**BOARD OF PUBLIC WORKS AND SAFETY  
Agenda Request Form**

RE: Franklin Greenways Trail Amphitheater  
Change Order #1

RE: Franklin Greenways Trail Amphitheater  
Change Order #2

RE: Franklin Greenways Trail Amphitheater  
Change Order #3

SHEET NO.: L201

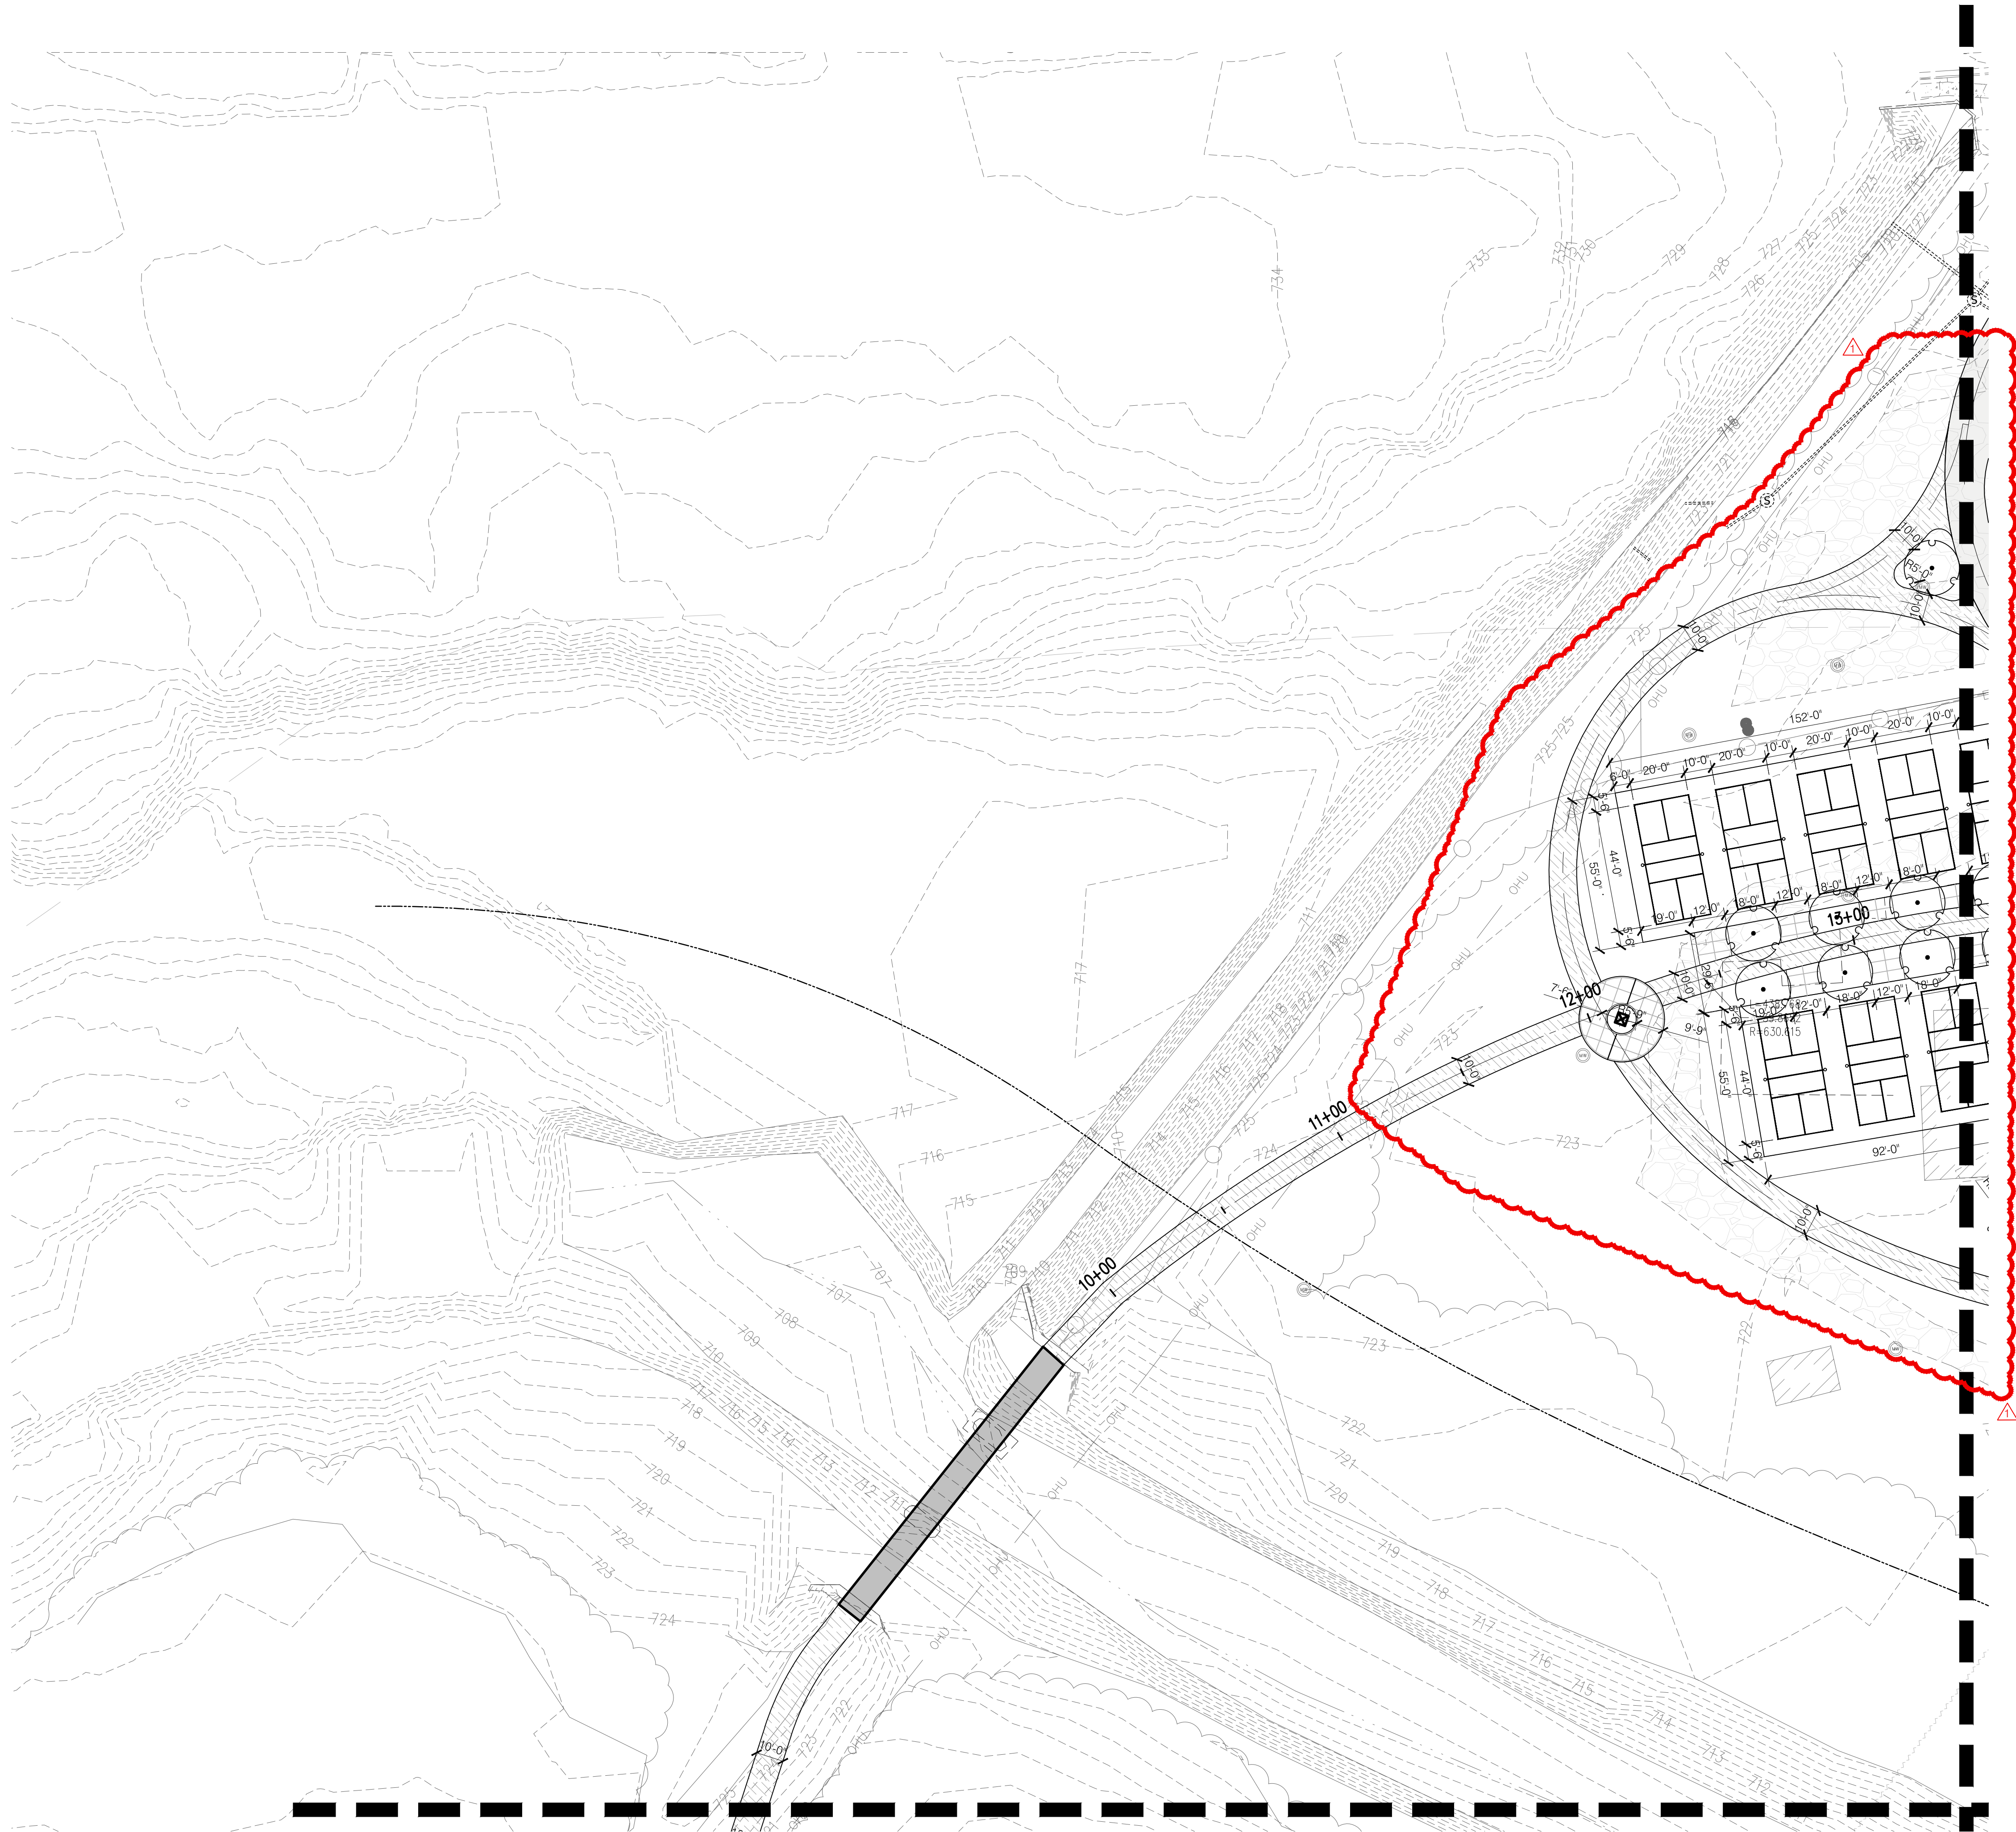
There are to be eight (8) pickleball courts installed as part of the project. Existing line items exist to pay for the earthwork and asphalt for the proposed courts and is not included in this change order. This change order is to address the acrylic surfacing, striping, and net installation of the eight (8) pickleball courts as this work falls outside of current contract work.

We have received updated plan sheets and specifications from Shrewsberry regarding the pickleball courts that are to be installed within the limits of the Amphitheater project. Myers needs to provide a unit price to complete the installation of the eight (8) pickleball courts. Pricing shall be provided on a per each basis for the items listed below. The work to construct the actual pickleball courts themselves will be paid for at the existing bid unit price for the Trail Asphalt Pavement Section of \$35.46/SYD.

DESCRIPTION	QTY	UNIT
Acrylic Surfacing of Pickleball Courts	8	EACH
Install Playing Nets on Pickleball Courts	8	EACH
Stripe Pickleball Courts	8	EACH
